File Number: 8-B-25-IH

Location: 205 Chickamauga Ave. **Parcel ID:** 81 B G 039
Zoning: RN-2 (Single-Family Residential Neighborhood)
Description:
New primary structure.

Level III New Primary Structure

8-B-25-IH
APPLICATION FOR CERTIFICATE OF APPROPRIATENESS

3

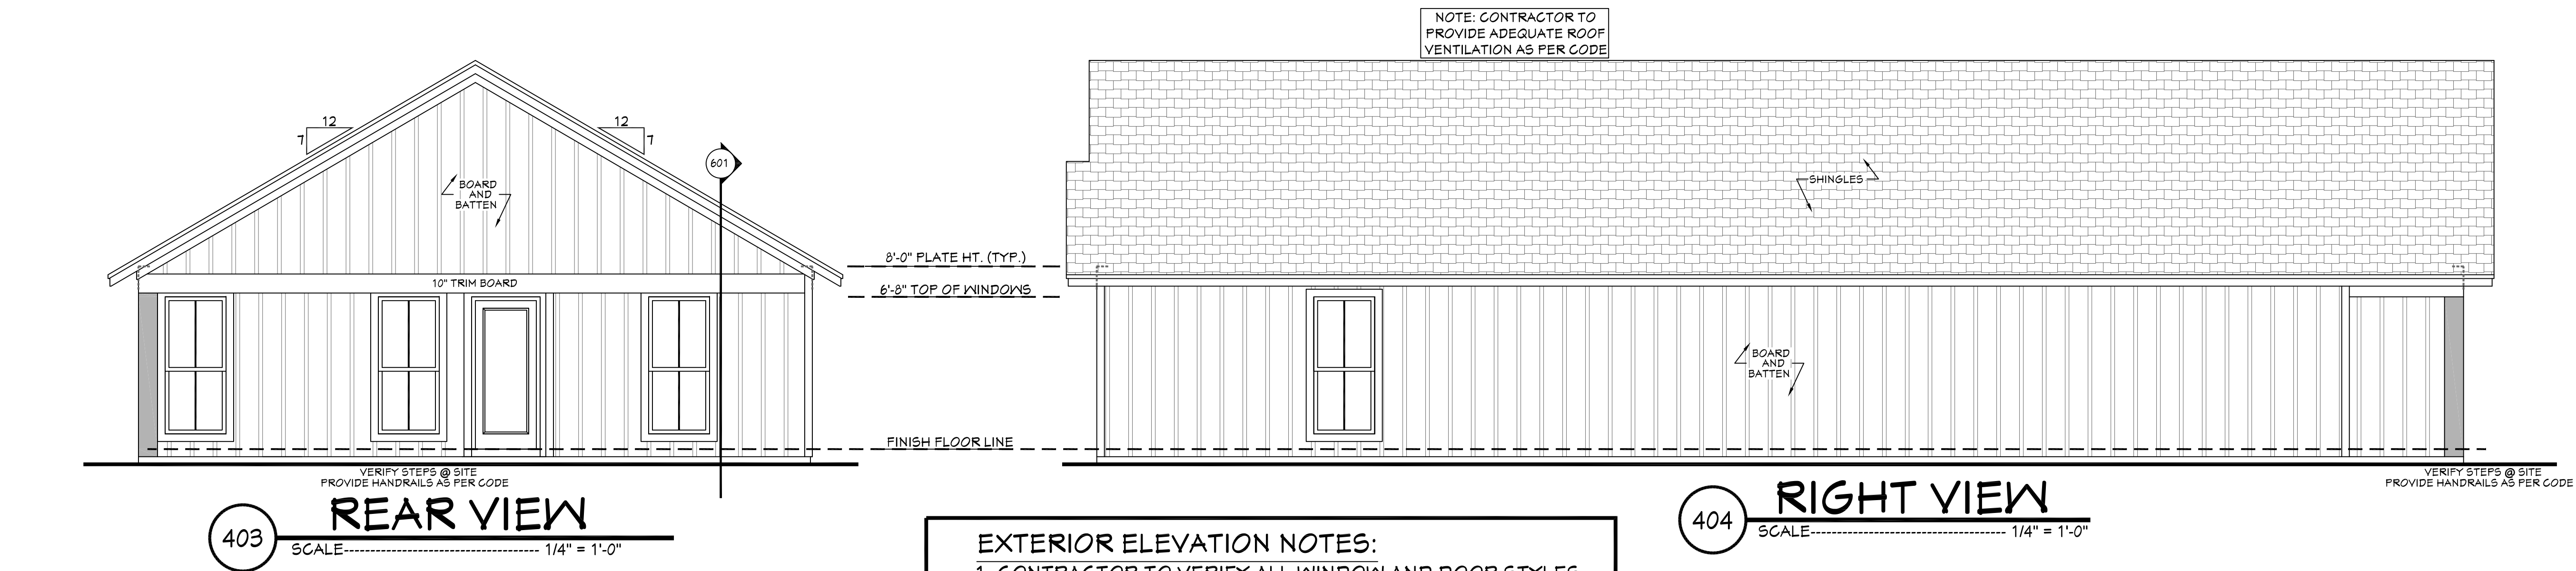
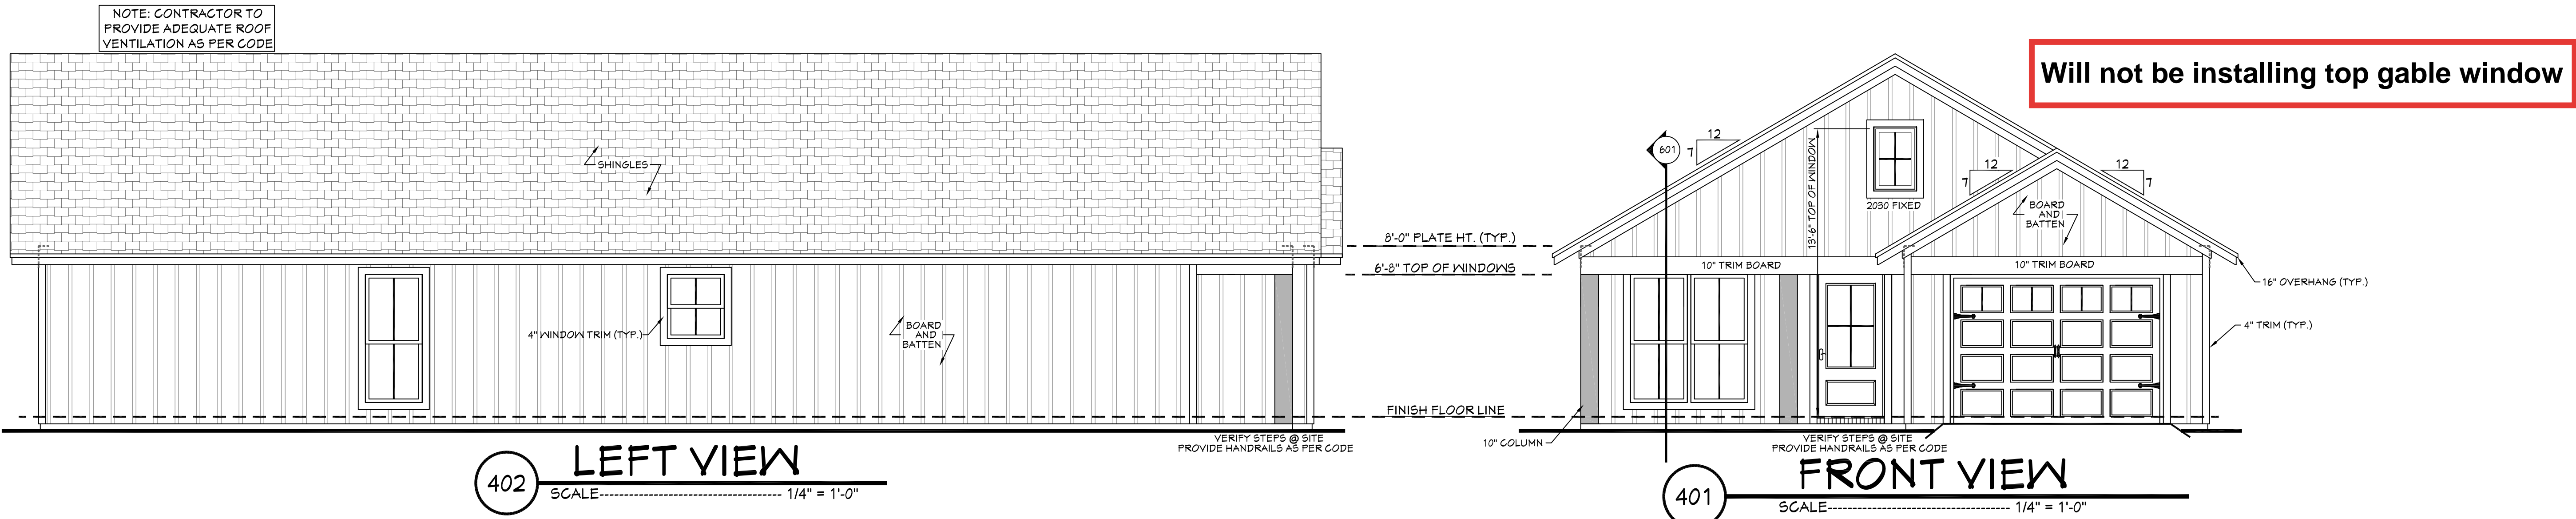
2. Parking is a two-car front-entry garage accessed via Chickamauga Avenue. Guidelines discourage front yard parking and state that "garages...should be at least 20 feet behind the front façade;" there are no houses on the block with front-entry garages. The front-entry garage should be omitted and replaced with a single lane driveway extending at least 20' behind the façade, or the garage should be revised in placement to the rear of the house, with access from the rear of the house. The final site plan should meet City Engineering standards.

4. The block to receive new construction is characterized by Minimal Traditionals, modified Queen Anne cottages, Craftsman bungalows, and infill construction. The design features details like eave overhangs, horizontal headers, and 2/2 windows that reflect the context. The 29'-6" wide by 59'-10" deep house is proportionate in width to the lot and other houses on the block. However, the house is approximately 10'-25' deeper than all other houses on the block, with the exception of an 85' deep townhouse development. The Board should discuss whether the depth of the proposed house is appropriate for the context.

The Board should discuss the depth of the proposed house. If deemed appropriate, staff recommends approval of Certificate 8-B-25-IH, subject to the following conditions: 1) final site plan to include a walkway from the front porch to the street; 2) final site plan to meet City Engineering standards; 3) parking to avoid the front yard and the garage to be either omitted or revised in placement to the rear of the house, with a revised façade elevation to be submitted to staff showing windows and siding in place of the garage door; 4) final site plan to include a tree in the

SHEET NUMBER
4

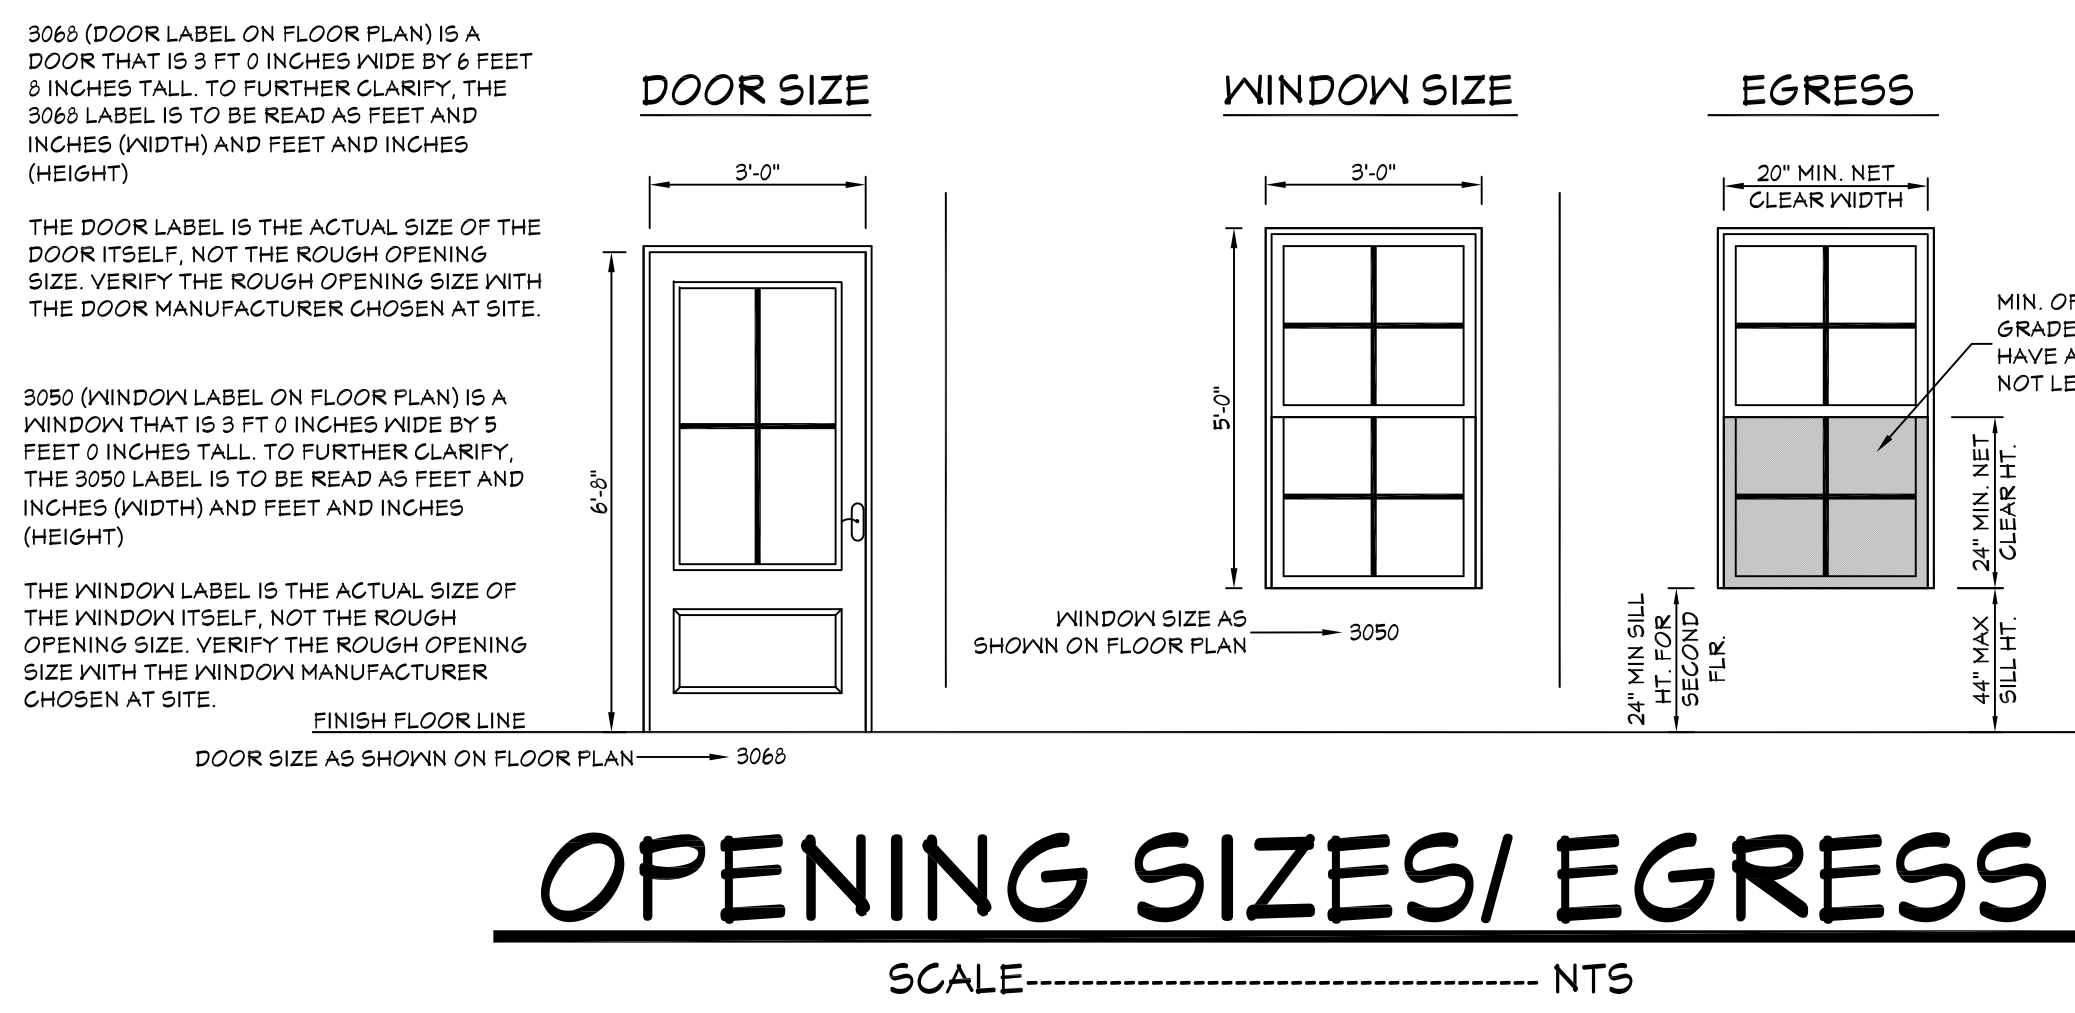
5. The three-bay, one-story façade is similar in height and scale to the context of the block, which primarily features one-story houses.
6. The design features a 4'-6" deep, half-length front-porch recessed under the primary roofline and supported by two 10" posts. The depth should be revised to at least 8' to meet the design guidelines.

7. Guidelines recommend window and door styles be similar to historic houses on the block with a similar ratio of solid to void. The 2/2 single-hung windows and half-lite paneled door match the context. The front, rear, and left elevations feature sufficient transparency, but an additional window should be added to the right elevation to avoid large swaths of blank siding.

8. The 7/12 pitch front-gable roof meets the design guidelines, and the design benefits from the eave overhangs, horizontal headers, and trim, which should be retained in final construction.

9. The asphalt shingles meet the design guidelines, and the slab foundation should be parge-coated or clad in stucco. The elevations depict board-and-batten siding on all sides of the house, but a note states that board-and-batten will only be used on the façade, with horizontal siding on the rest of the house. Guidelines discourage the use of vertical siding and multiple primary siding materials, and board-and-batten is typically only approved as an accent. Clapboard-style lap siding with an overlap should be used as a primary siding material on all elevations, with board-and-batten used as an accent in the gable fields and on the projecting front-gable massing, if desired.

front and rear yards; 5) the porch depth be revised to at least 8'; 6) an additional window be added to the right elevation, to be approved by staff; 7) final construction to retain the eave overhangs, horizontal headers, and trim as depicted on the elevations; 8) foundation be parge-coated or clad in stucco; and 9) clapboard-style lap siding be used as the primary siding material on all elevations with board-and-batten as an accent only.
